Amendments to the Drawings

REMARKS

Summary of the Office Action

FIG. 1
(Prior Art)

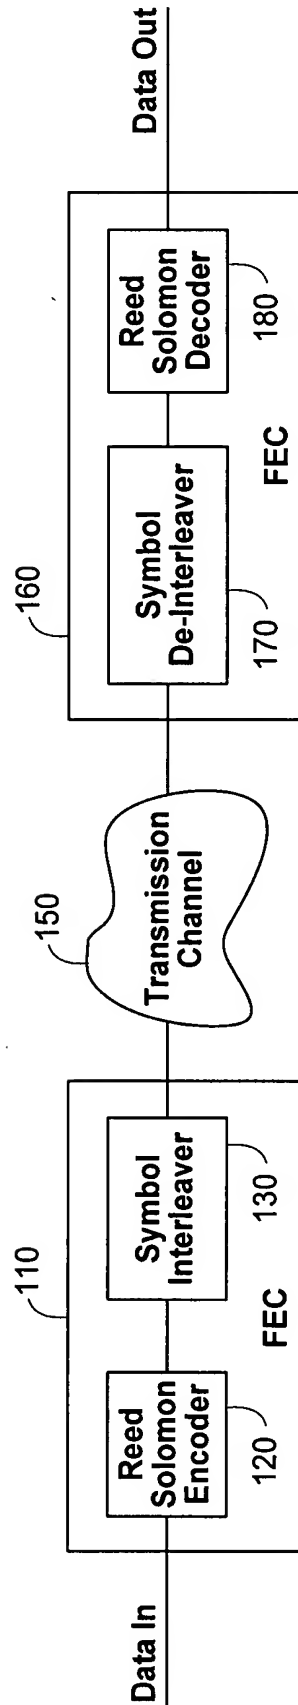
The Examiner objected to FIGS. 1 and 2 for not being designated as "Prior Art."

FIGS. 1 and 2 were objected to for not being designated as "Prior Art." Applicants have amended FIGS. 1 and 2 to insert the "Prior Art" designation. Accordingly, applicants respectfully request that the Examiner's objection to FIGS. 1 and 2 be withdrawn.

FIG. 5

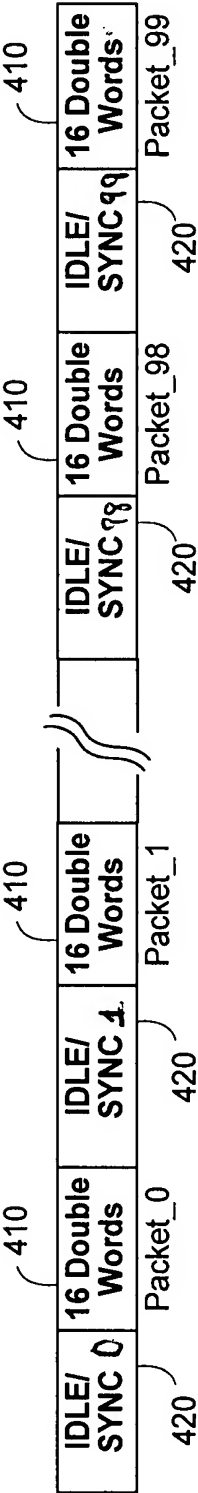
The Examiner also objected to the drawings under 37 C.F.R. § 1.83(a) for not showing every feature of the invention specified in the claims. Specifically, the Examiner objected to the drawings for not showing the "plurality of sequential identification packets."

The drawings were objected to under 37 C.F.R. § 1.83(a) for not showing every feature of the invention specified in the claims. Specifically, the Examiner objected to the drawings for not showing the "plurality of sequential identification packets." Applicants have amended FIG. 5 to insert the sequence numbers of IDLE/SYNC packets 420.
